MERIDIAN OIL

PID Measurement for Unlined Pit Closure Assessment Field Screening

RE: Pit remediation at the Meridian Calloway #1A and Larcher #1

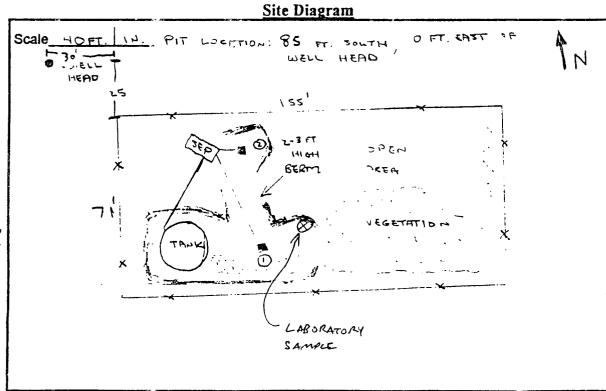
The Oil Conservation Division District III office has determined there is insufficient data available to approve the Meridian pit closures at the Calloway #1A, O-27-31N-11W and the Larcher #1, K-7-31N-10W. The OCD needs evaluation of the impact of Total Petroleum Hydrocarbons left in place. I suggest you review the ranking criteria and risk analysis outlined in the Draft OCD Surface Impoundment Closure Guidelines dated 12/21/92. The volume of contaminated material is a significant factor in risk analysis. Down dip auger testing with PID screening is one option which should indicate the volume of contamination at these locations. At the Larcher #1 more than one core hole may be needed and depth to groundwater may need to be determined because a Total Petroleum Hydrocarbon reading of near 25,000 ppm may indicate persistent BTEX contamination near the water table within the river valley.

Meridian Oil Inc. has until February 15, 1993, to respond with an outline for further remediation at these locations and provide a date for completion of these activities. The OCD District III office is to be notified twenty-four hours before further remedial activity is initiated.
